Planning Commission Memo

Re: Brown Trout LLC Variance Application at 15311 Putnam Boulevard and Minor Subdivision Application at 15311 Putnam Boulevard and 2573 Stagecoach Trail - **Supplemental**

Re: Brown Trout LLC Variance Application at 15311 Putnam Boulevard and Minor Subdivision Application at 15311 Putnam Boulevard and 2573 Stagecoach Trail

SLOPES & BUILDABLE AREA
SHEET NO.
1 OF 1

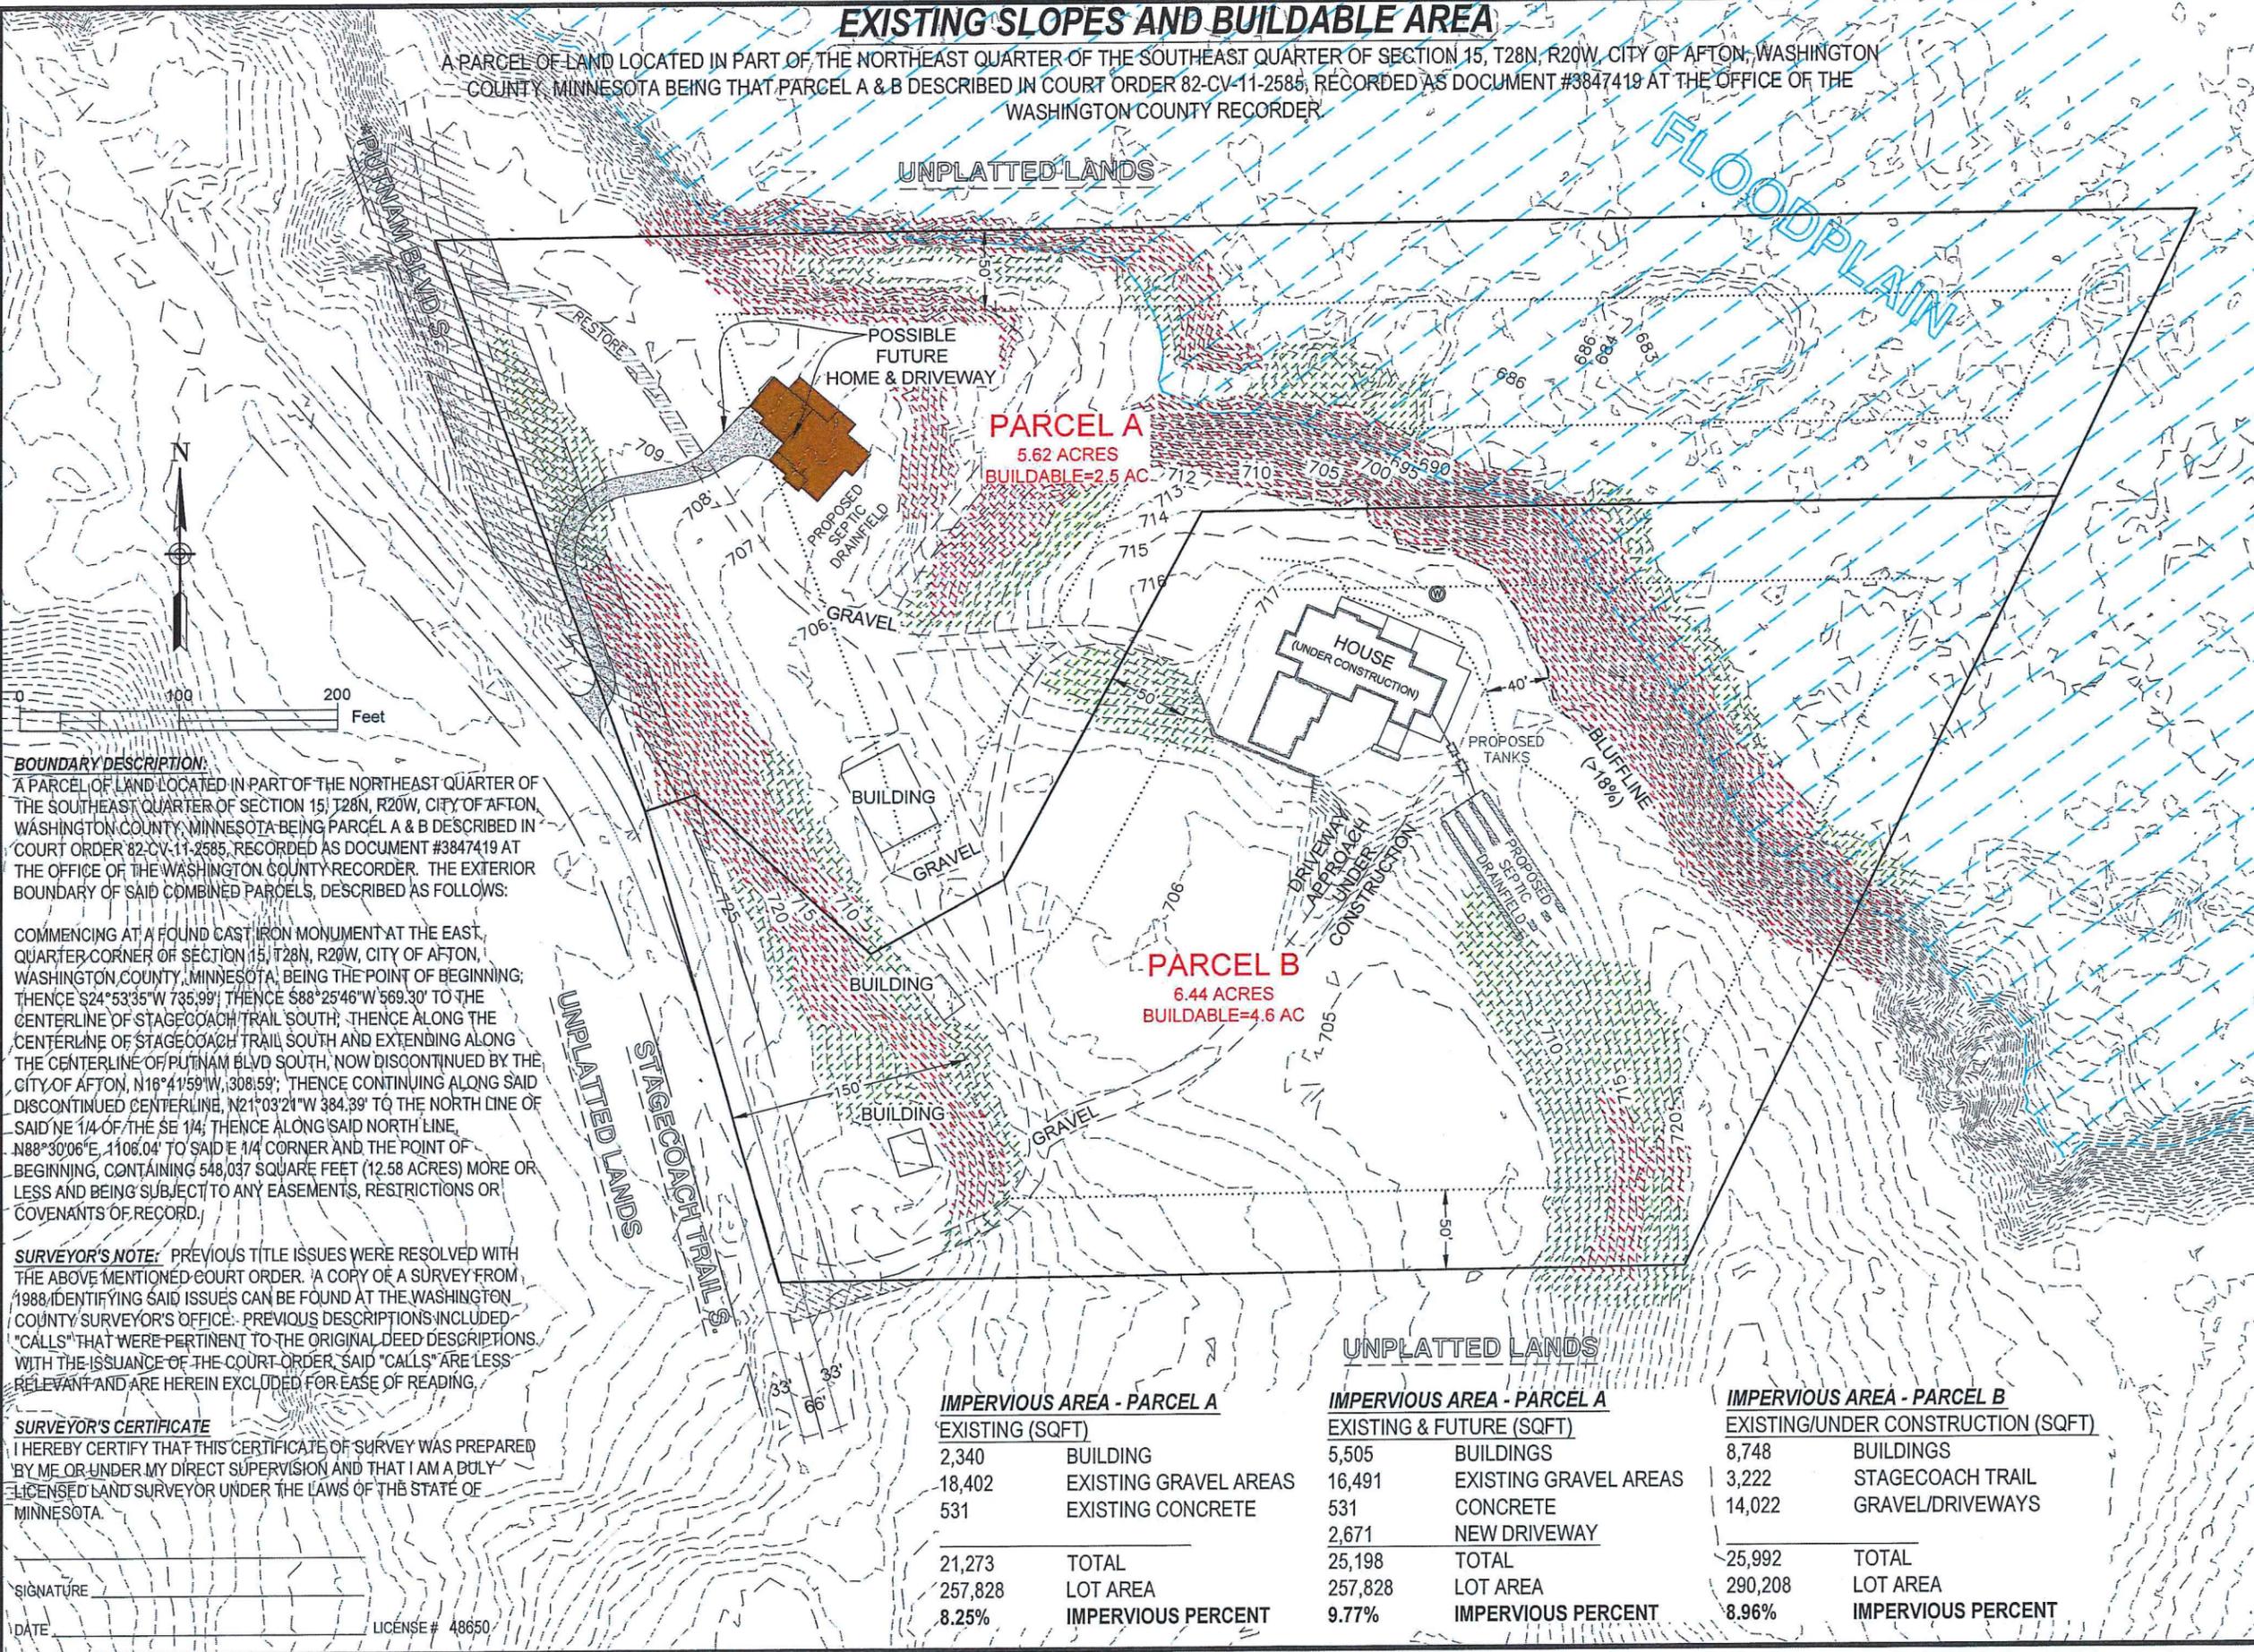
Dedication of Easements. The City Engineer has indicated drainage and utility easements are required along the perimeter of each parcel – 10 feet wide along the front and rear property lines and 5 feet wide along the side property lines. These easements are to be reflected in the subdivision survey, and dedication of drainage and utility easements as required by the City Engineer should be a condition of approval.

The properties involved in the subdivision include significant areas of land with slopes of 18% or greater. To protect these areas with steep slopes, they should be placed into scenic easements as part of the subdivision process.

Driveway construction will need to comply with Section 12-84 of the Zoning Ordinance and be subject to review and approval by the City Engineer. A license to use the public right-of-way for the driveway to serve the Putnam Boulevard parcel would need to be recorded with the subdivision.

1. Easements as required by the City Engineer shall be granted
2. All drainage and utility easements shall be subject to the review and approval of the City Engineer.
3. All grading, drainage and erosion control plans shall be subject to review and approval by the City Engineer, and by the Valley Branch Watershed District if they meet permit thresholds.
4. Scenic easements shall be placed on all slopes greater than 18%
5. The applicant shall execute a scenic easement agreement and shall record the scenic easement concurrent with the subdivision
6. Driveway construction shall comply with Section 12-84 of the Zoning Ordinance and be subject to review and approval by the City Engineer.
7. A license to use the public right-of-way for a driveway to serve the 15311 parcel shall be recorded with the subdivision

PROPOSED FUTURE DRIVEWAY AND TRAIL

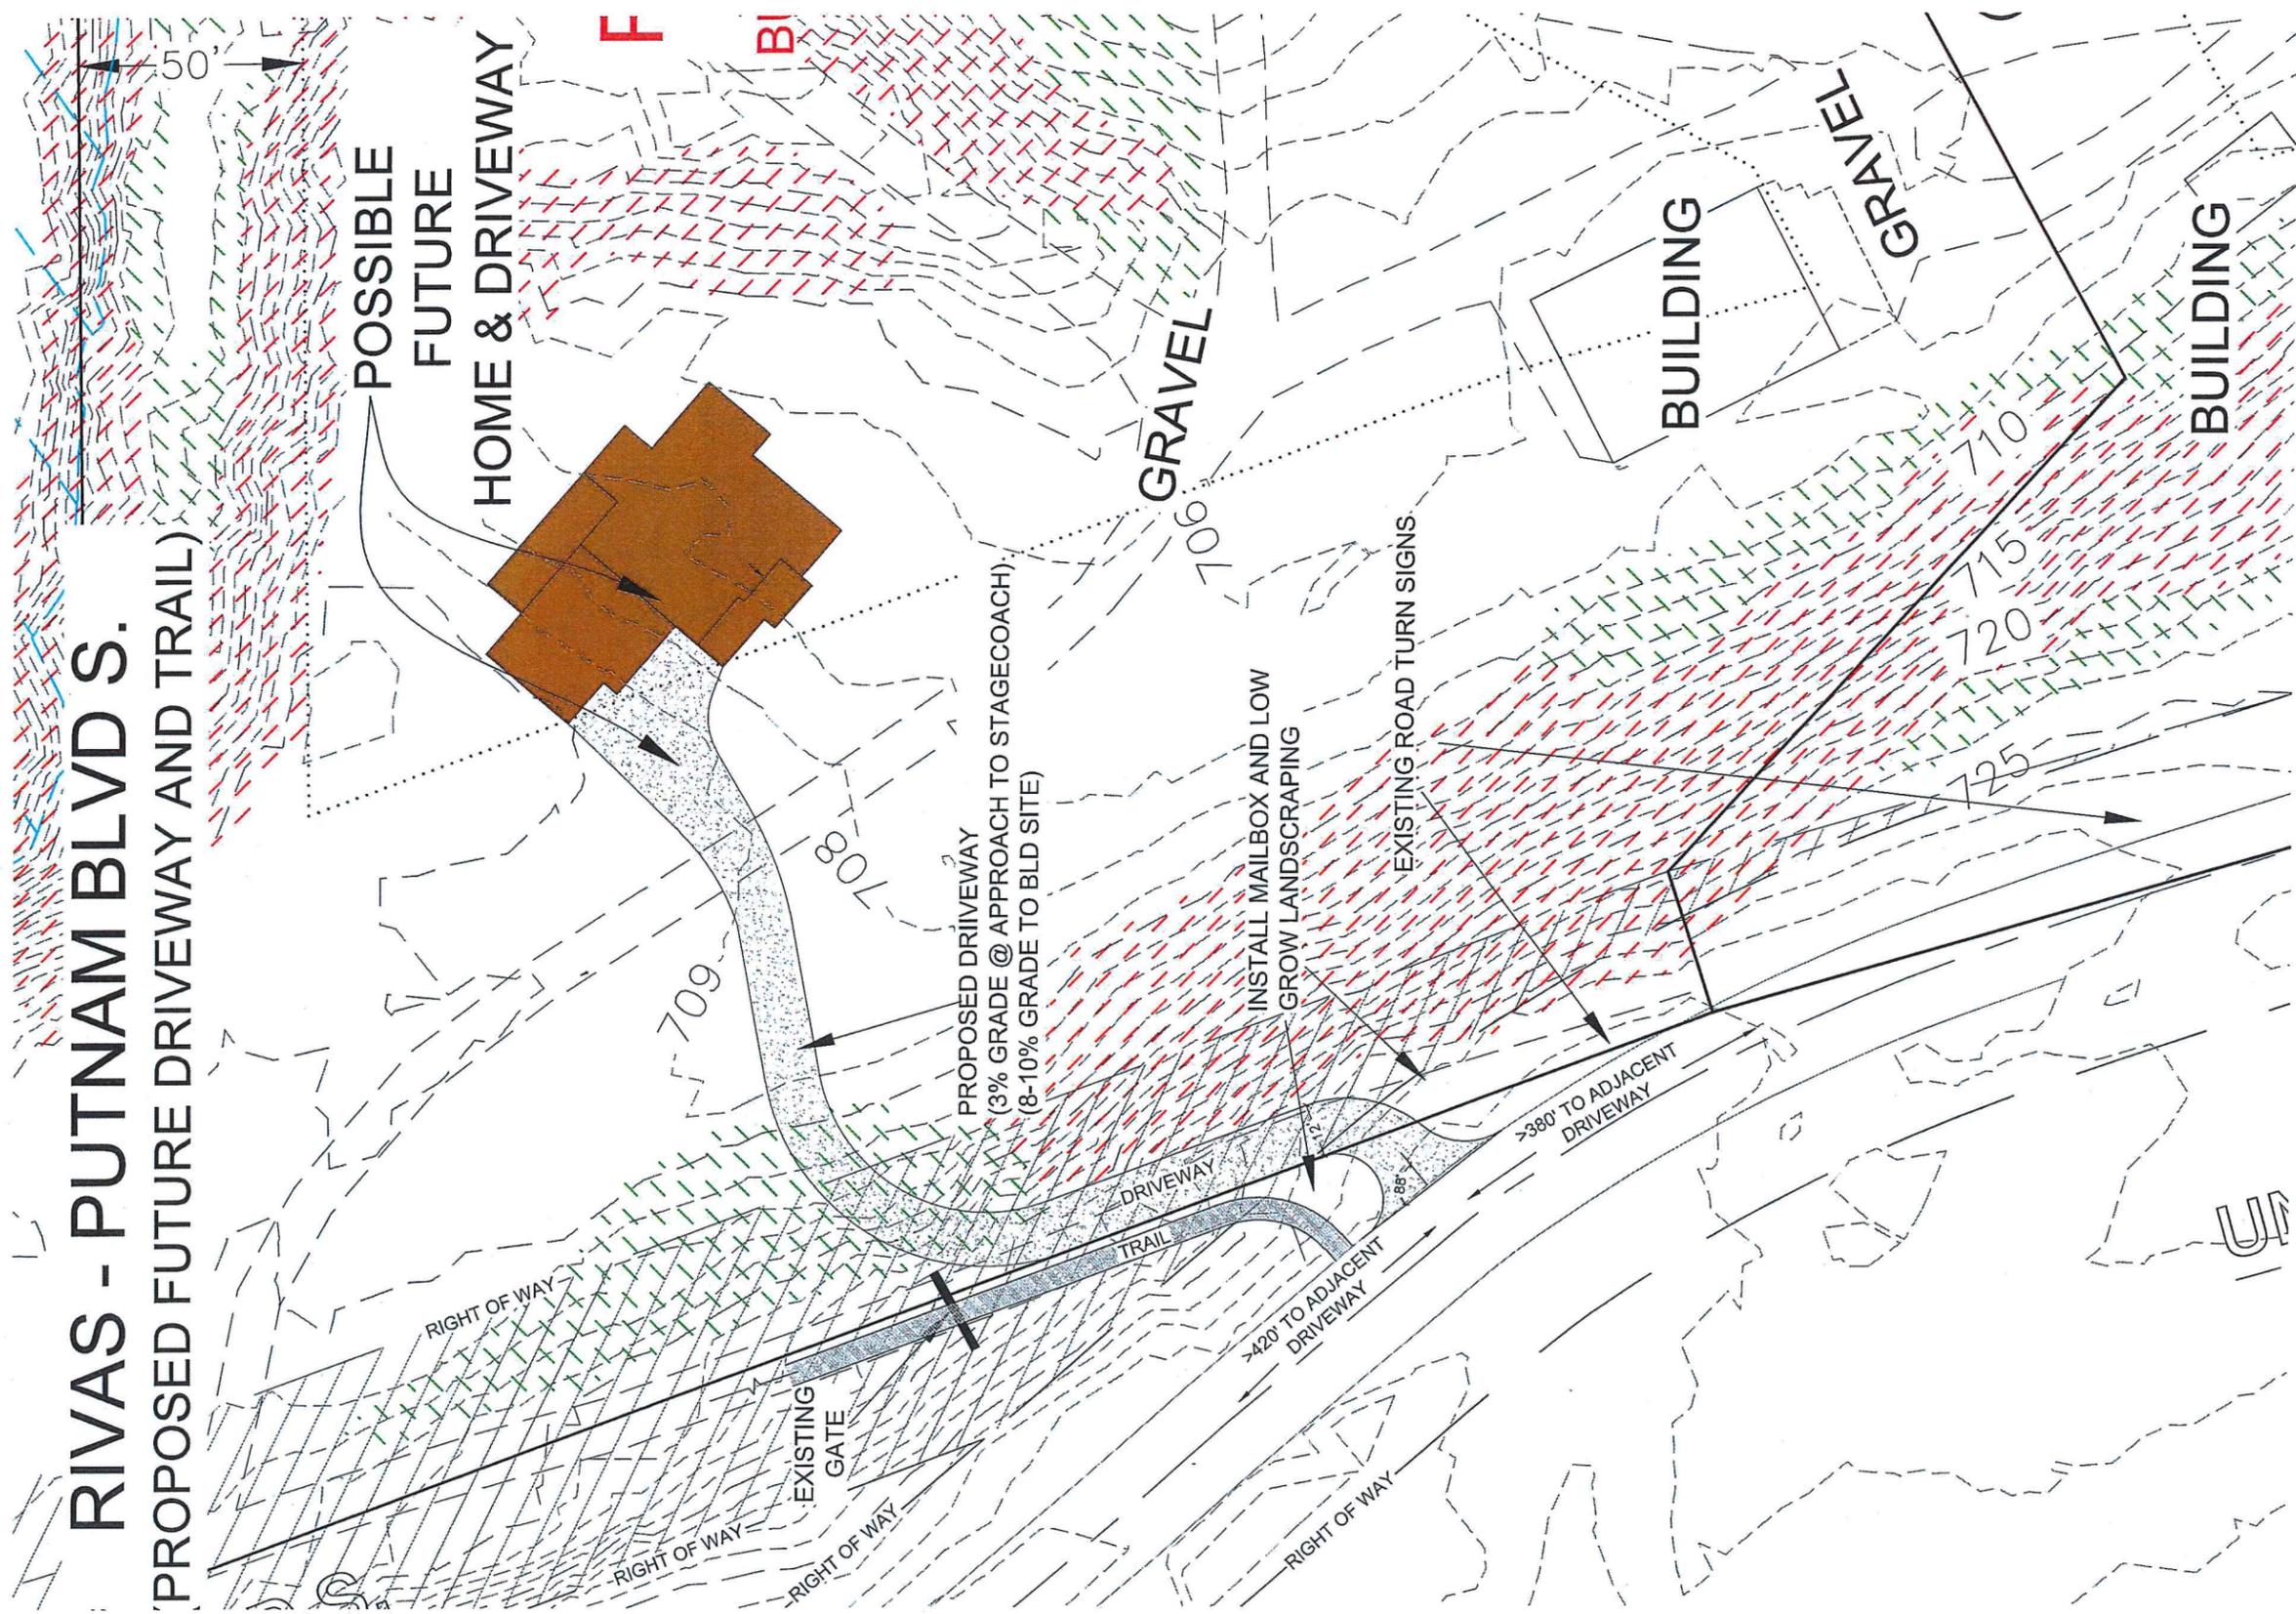
3. The City closed Putnam Boulevard to traffic, but did not vacate the Putnam Boulevard right-of-way
4. The proposed driveway location to access the 15311 Putnam Boulevard parcel would require a license to use the Putnam Road right-of-way.
